# **KINGSVILLE DOME URANIUM MINE AREA DATA AND ANALYSIS (A Work in Progress)**

## **May 06, 2013 QUESTIONS**

**EPA, Region 6  
Dallas, Texas**

# Questions on Log Scales and Nomenclature

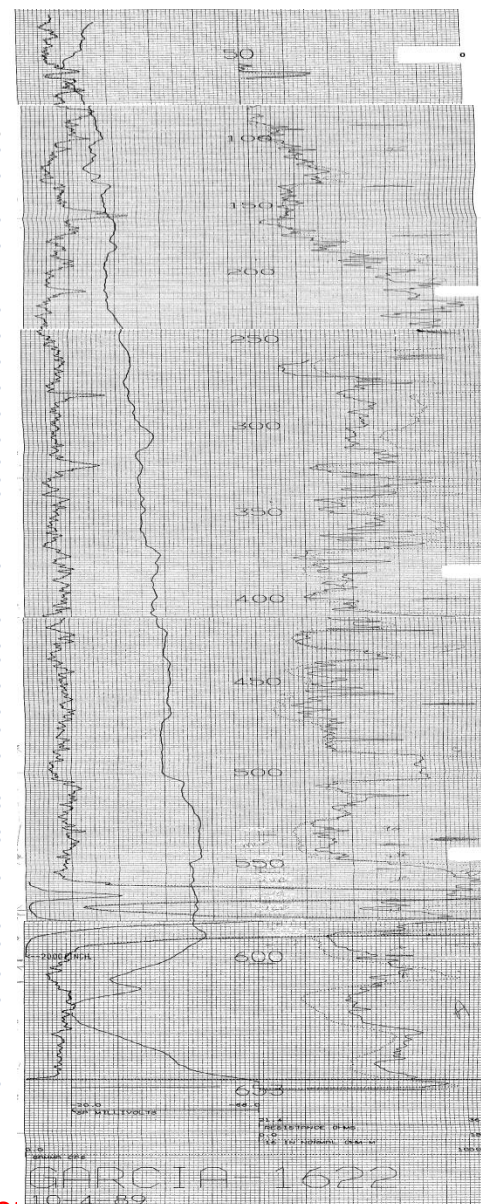
The Fermin Garza Well is completed in the "B Sand"

There is a difference in elevation between the F. Garza Well and Garcia 1622 of about 25 Ft.

#### Exploratory Well – Garcia 5

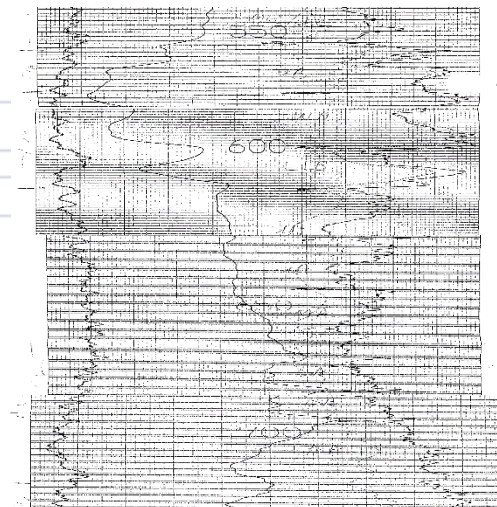
The Garcia 5 Well penetrated the “B”, “A” and “AA” Sands, which do not appear to contain uranium ore at this location. It is located approximately 1146 Ft from the Garcia Hill W-25 and 860 Ft from the Garcia Hill W-24.

The Garcia Hill W-25 well is completed in the “B Sand” and the Garcia Hill W-24 appears to have gone down to the “AA Sand”, per analogy with the Exploratory Garcia 5 Well Log.

How probable is it that the W-24 and W-25 Garcia Hill Wells may have penetrated uranium ore bodies?. No logs are currently available for these wells.

KVD PA-3 Segment. Was Exploratory Well Garcia 1622 Completed as a "B Sand" (?) Producer 13222?.

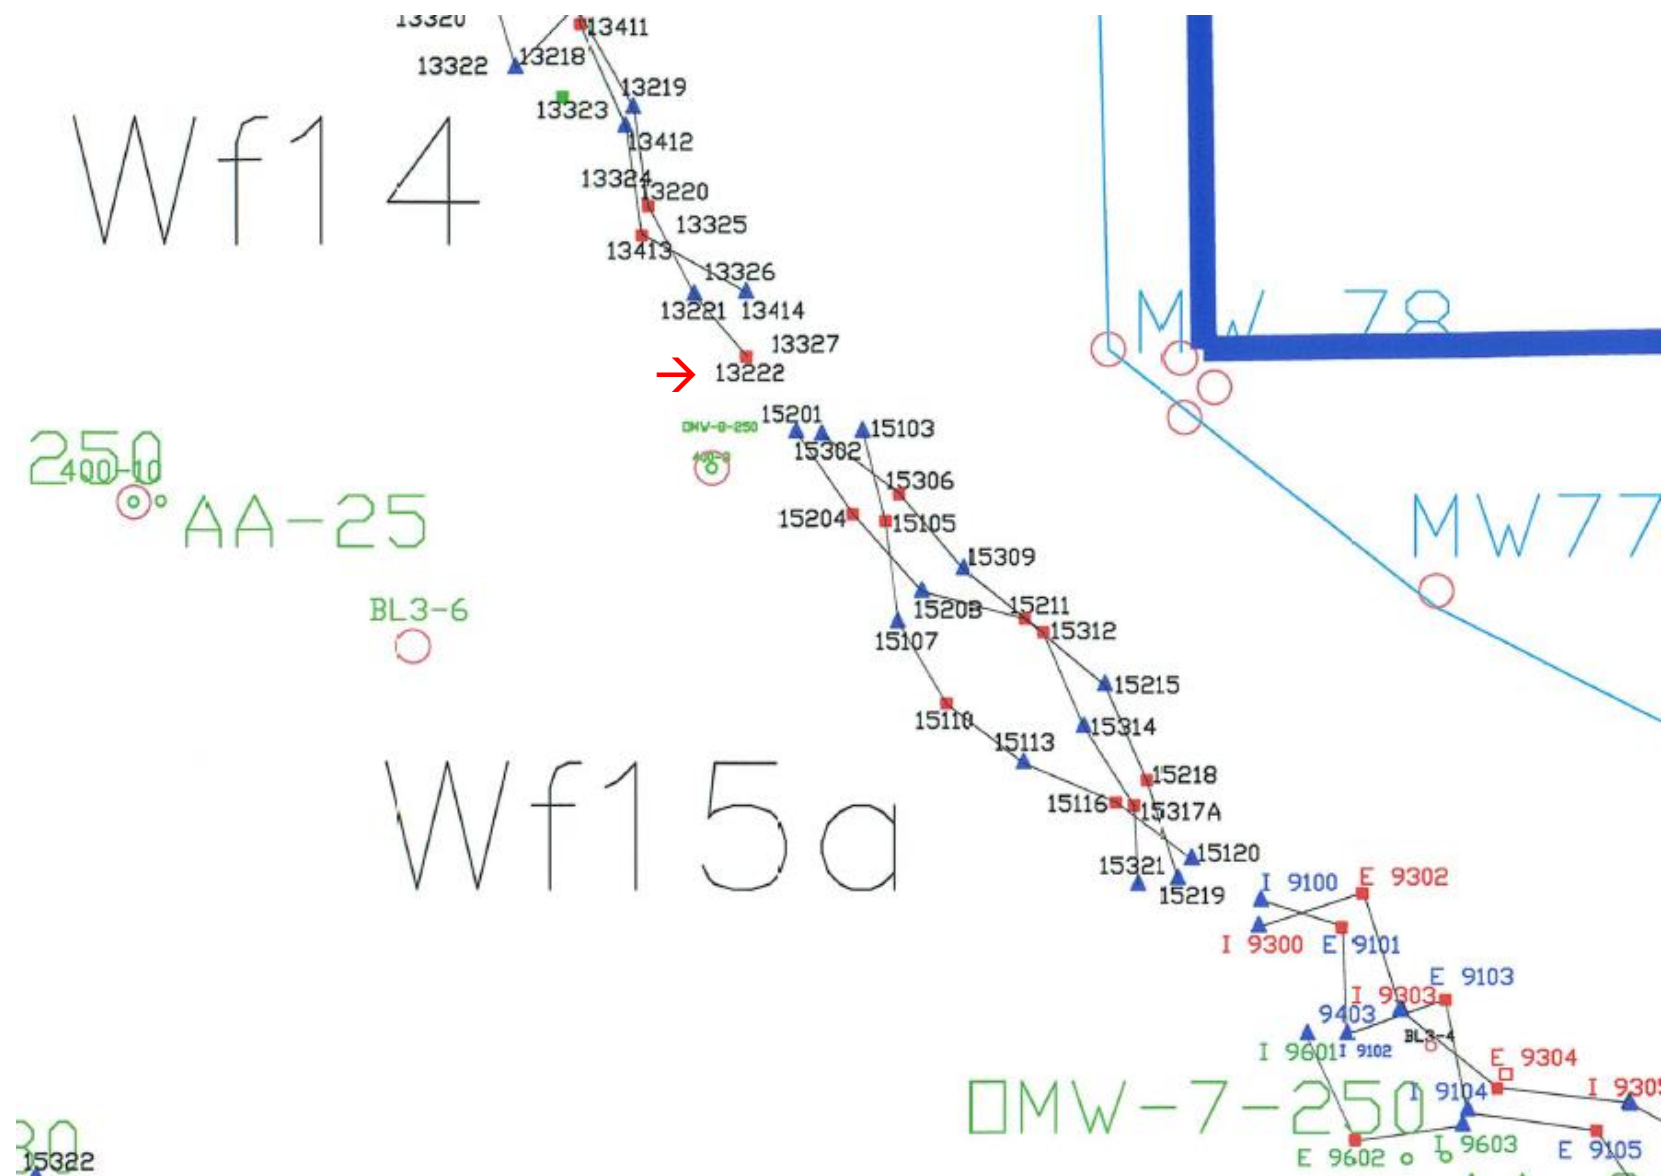
Note that Injector 13326 is not connected to 13222 suggesting completion in different zones.

Is there information documenting Which Sands were produced at PA-3?
